2006 - 2009 Cadillac XLR XLR-V: Service Bulletin: Slips in Reverse or Third, Delayed Reverse or Drive Engagement

#09-07-30-004J: Slips in Reverse or Third, Delayed Reverse or Drive Engagement, DTC P0776, P2715, P2723, Harsh 2-3 Shifts (Inspect 1-2-3-4 / 3-5-R Housing and Pump Seal Rings) - (Feb 25, 2014)

This bulletin has been revised to update the 2006 - 2009 Vehicles correction

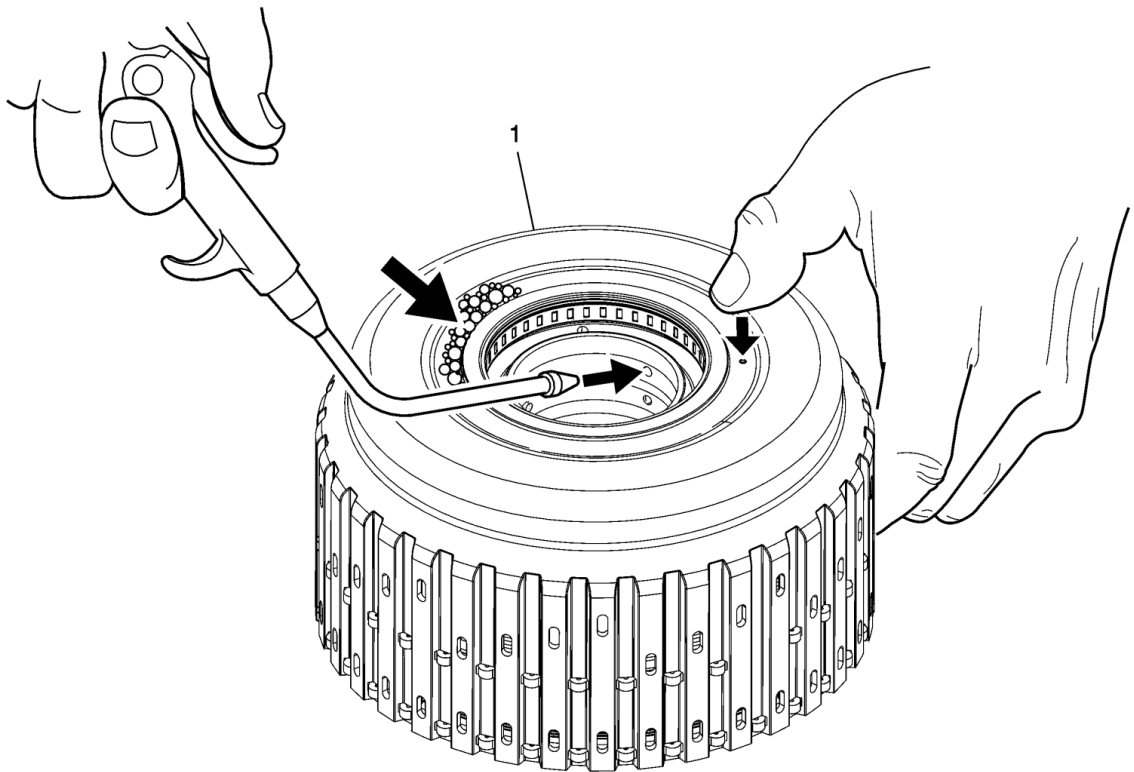
This condition may be caused by a cracked 1-2-3-4 / 3-5-R clutch housing.

Important: If a cracked housing is identified, it must be replaced. Complete, assembled 1-2-3-4 / 3-5-R clutch housings are now available for most applications. These clutch housings come complete with all pistons, seals, clutches, bearing and internal parts. No assembly of the clutch housing is required before it is installed. For applications without a complete, assembled 1-2-3-4 / 3-5-R clutch housing, individual parts must be ordered and the housing assembled in the

Housing Disassembled

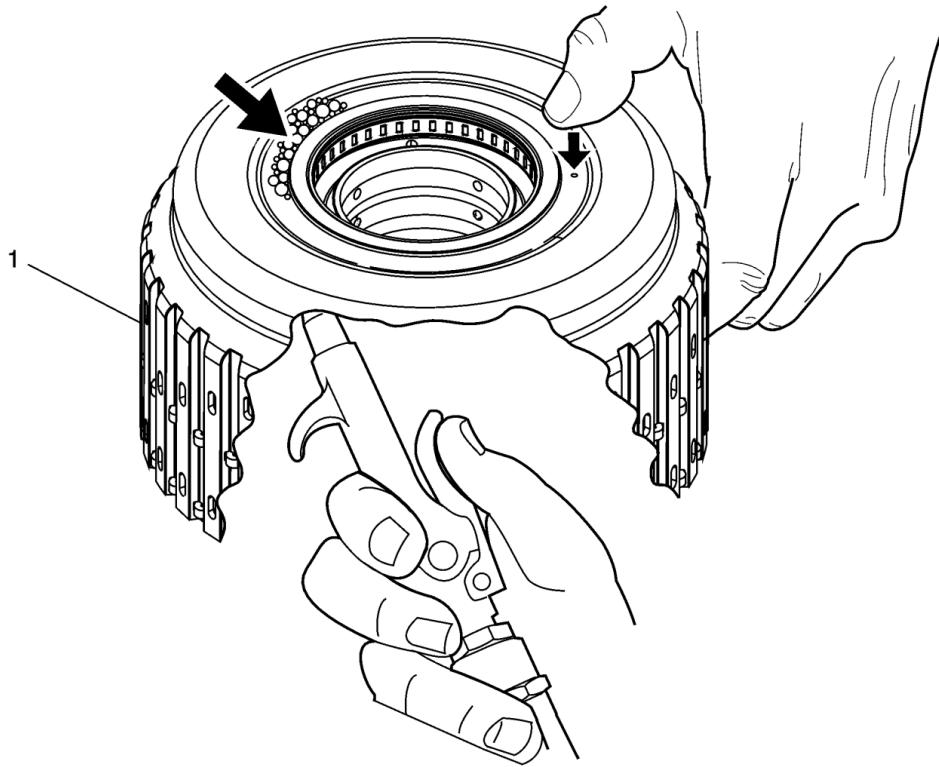
Inspect the 1-2-3-4 / 3-5-R clutch housing for a possible cracked weld.

1. Apply soap compound to weld area of the housing.
2. Hold your thumb over the air bleed passage.
3. Spray compressed air into the housing and inspect the weld area for bubbles.
4. If bubbles are detected, a new housing is required.

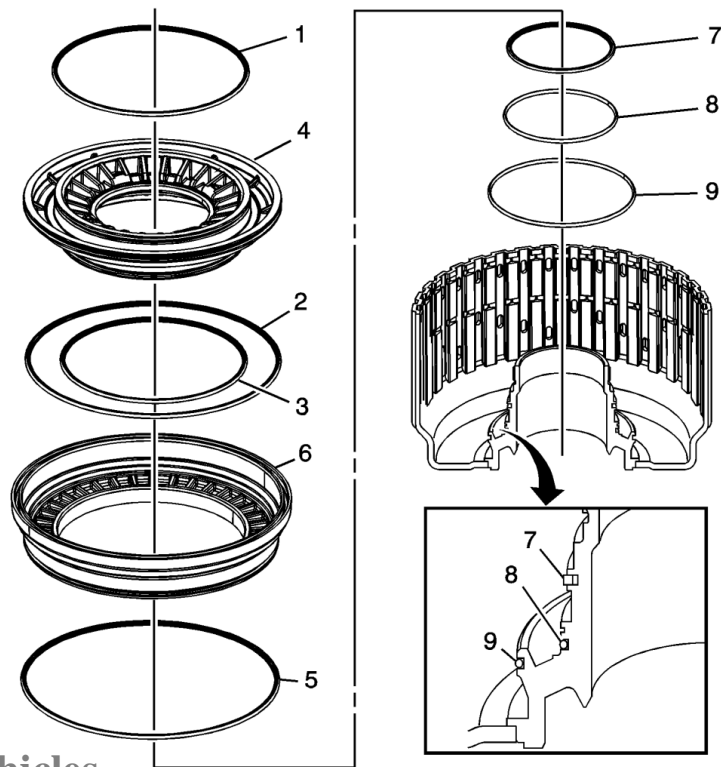
Important: When installing a new 1-2-3-4 / 3-5-R hosing into a 2007 or older 6L80, be sure to install all three (3) inner seals (7, 8, 9 in illustration below). Failure to install these seals can result in no reverse, no forward or distressed clutches.

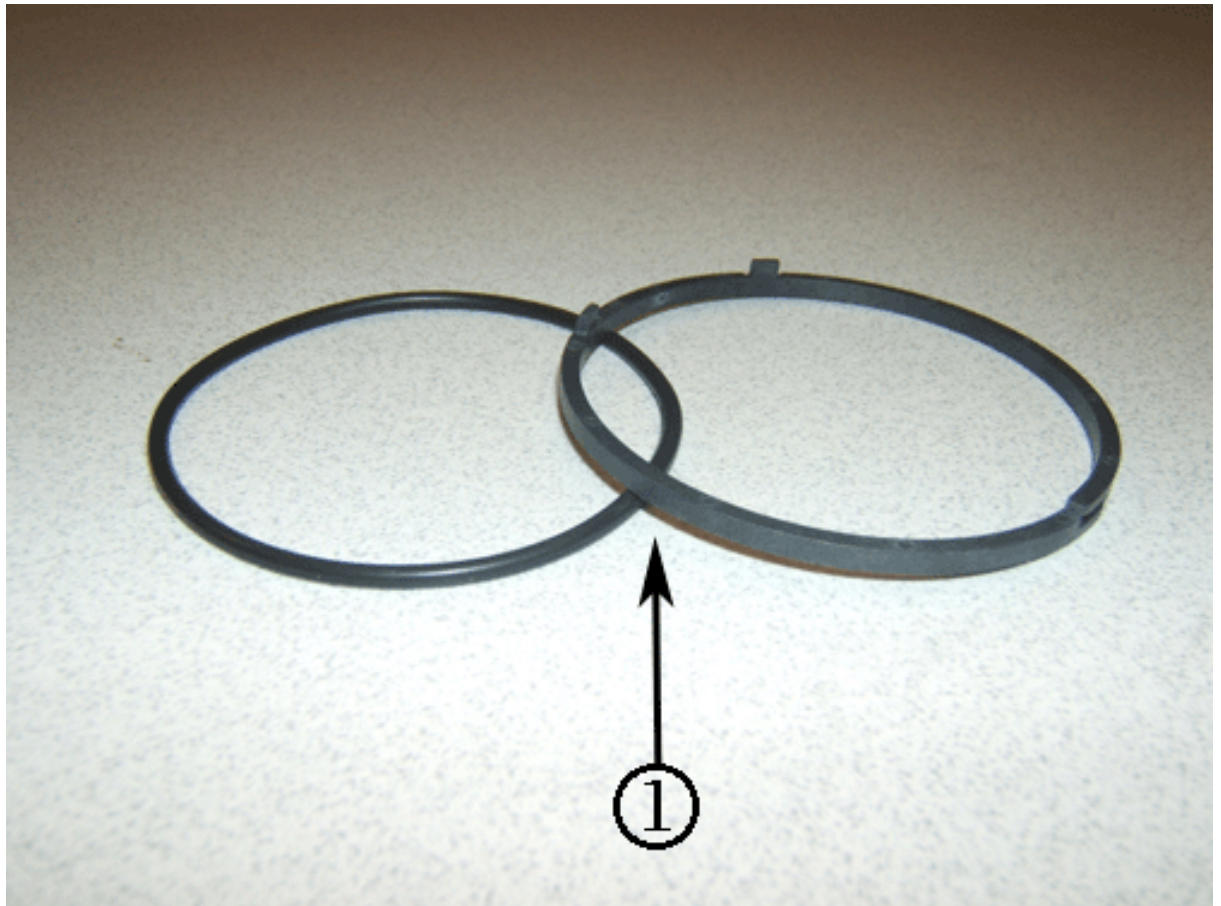
A harsh 2-3 shift condition may be caused by leaking 1-2-3-4 and 3-5-R clutch fluid seal rings (1) on the transmission fluid pump cover assembly.

Inspect the fluid seal rings. Transmissions in 2006, 2007, 2008 and early build 2009 models used a 1- piece design seal ring in production. Starting December 2008, a 2-piece seal ring design was implemented. The 1-piece seal ring design may cause a harsh 2-3 shift due to leakage. This is typically a low mileage issue. If the seal rings are a 1-piece design they should be replaced with new 1-piece design seal rings. It is not necessary to replace the pump cover.

Notice: The clutch fluid seal rings must be installed in a specific way. Failure to install new clutch fluid seal rings in the proper orientation may cause a repeat harsh 2-3 shift. Refer to 1-2-3-4 and 3-5 Reverse Clutch Fluid Seal Ring Installation (6L80/90) in SI for correct installation.
